SERVICE BULLETIN

Service Bulletin No. 2013-02

SUBJECT: Alternator fan

Picture 1

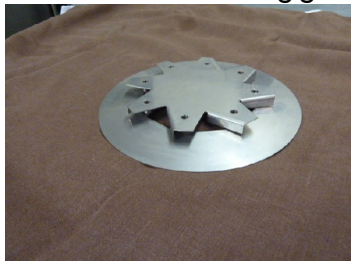
The new design is without welding.

Between the 2 parts are distance rings. A longer bolt (M6x30) keep the parts on place and fix them to the starter ring gear (see parts catalogue)

Check if the engine is equipped with a fan conform picture 1 and 2.

If necessary, change the old type fan by the new one.
